Docket Number:	15-BSTD-04
Project Title:	Residential and Nonresidential Software and related ACM Reference Manuals
TN #:	205787
Document Title:	Natural Resources Defense Council Comments on Draft Residential ACM Reference Manual
Description:	N/A
Filer:	System
Organization:	Natural Resources Defense Council/Meg Waltner
Submitter Role:	Public
Submission Date:	8/20/2015 3:56:08 PM
Docketed Date:	8/20/2015

NRDC Comments on Draft Residential ACM Reference Manual

NRDC Comments on the 2016 Draft Residential Alternative Calculation Method Reference Manual
Docket #15-BSTD-04
August 20, 2015

Figure 3: Comparison of Gas and Electric TDV values in Climate Zone 12⁹

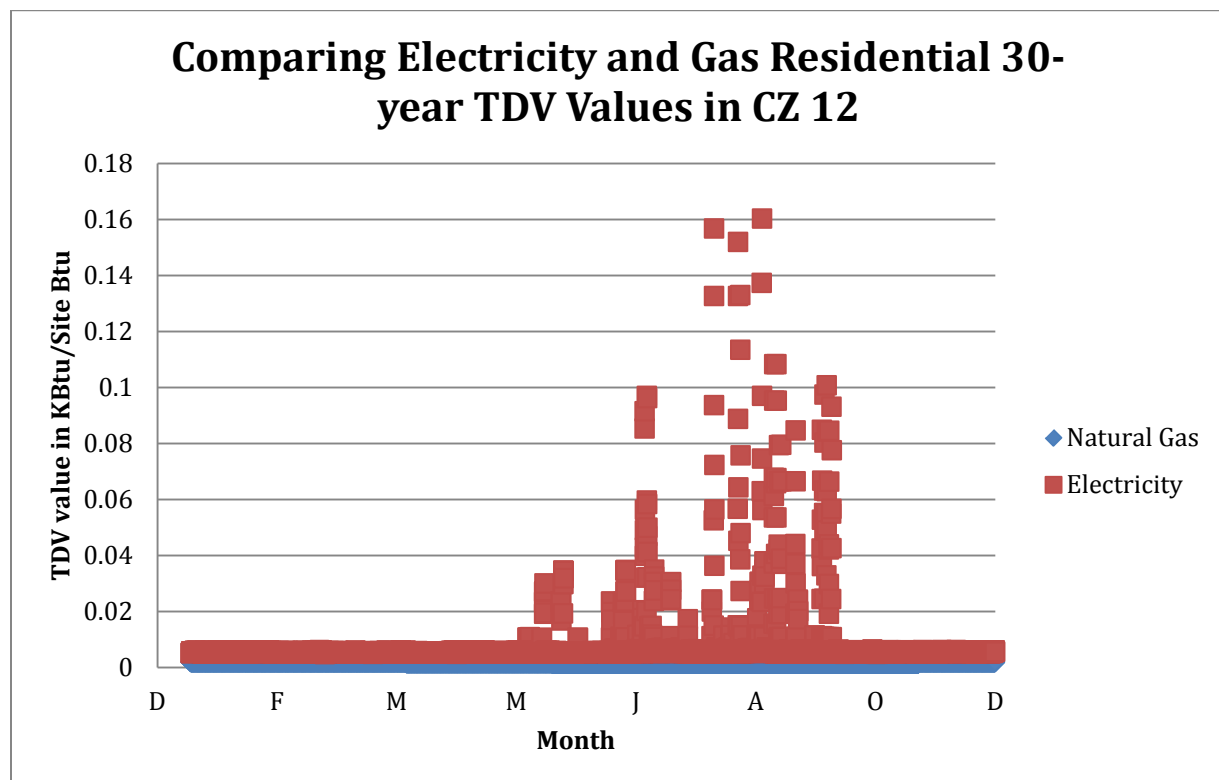
The below graph shows the TDV values of electricity and gas for climate zone 12, adjusted to a common denominator of site Btu. The TDV value of electricity is roughly three times that of gas in off-peak hours and over 100 times that of gas in the highest peak hour. This is questionable, and may have material impacts. For example, it has the effect of highly favoring the use of gas over electricity, especially for space and water heating equipment, where gas equipment is used in the reference design. This wasn't a material issue in the past due to the clear superiority of gas for heating. However, there are now updated heat pumps, and a growing capability for grid-interactive water heaters to dynamically avoid high-cost periods in real time. These developments offer a potentially significant benefit which requires further consideration.

This difference could set up a self-inconsistent process, in which the TDV values cause homebuilders to prefer end-use gas to electricity, and result in a shortfall in meeting 2050 emissions goals. The consequence of this shortfall will be a large increase in the cost of carbon, which will affect the cost of gas a lot more than the cost of electricity (since by 2030 or later, the electric system will be based mostly on renewables or very-high efficiency gas generation).

In the short term, *the CEC should address this issue this code cycle by using the same fuel type in the reference and proposed design, which would make the standards fuel neutral.* For residential, the CEC should use a large electric heat pump water heater in the reference design and a minimally compliant heat pump space heater. In the long term, the CEC should work to make sure that TDV better encompasses full environmental costs and benefits, consistent with achieving the state's 2050 carbon emissions reduction goal, in next TDV update.

Figure 4: Average Annual Electric TDV Values for CZ12 show the constant RPS adder.¹⁰

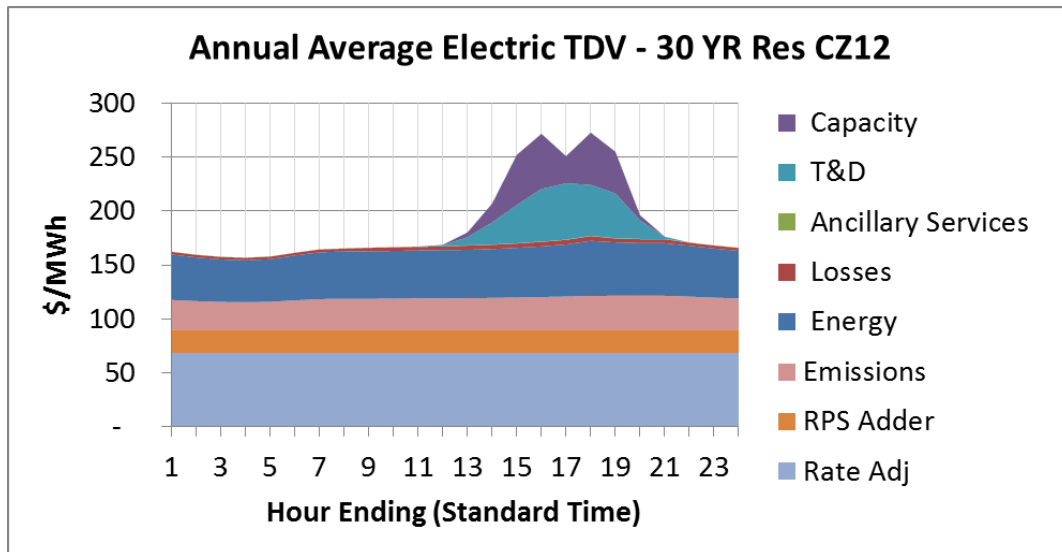
One reason for the large difference in current gas and electric TDV values is the method for valuing renewables in the electricity TDV calculations. Under the current methodology, renewables are considered as an additional avoided cost, calculated by multiplying the percentage RPS by the MWh avoided and the \$/MWh factor for renewables (See Figure 4). This means that the higher the assumed penetration of renewables, the higher the value of avoided electricity and the higher the cost of electricity compared to gas. This is counter to the result that would lead to the best societal outcome: the more renewables are used to generate electricity for new homes, the more TDV encourages gas rather than the renewables-heavy electric option. Clearly, the outcome should be the reverse: the more renewables used to generate electricity, the more favored electricity should be as a fuel choice.

We urge the CEC to address this issue in the next TDV update. In doing so, CEC should use best available estimates for renewable penetration and efficiency. We think that the current estimates used for the 2016 TDV are conservative and that other assumptions would be more appropriate.
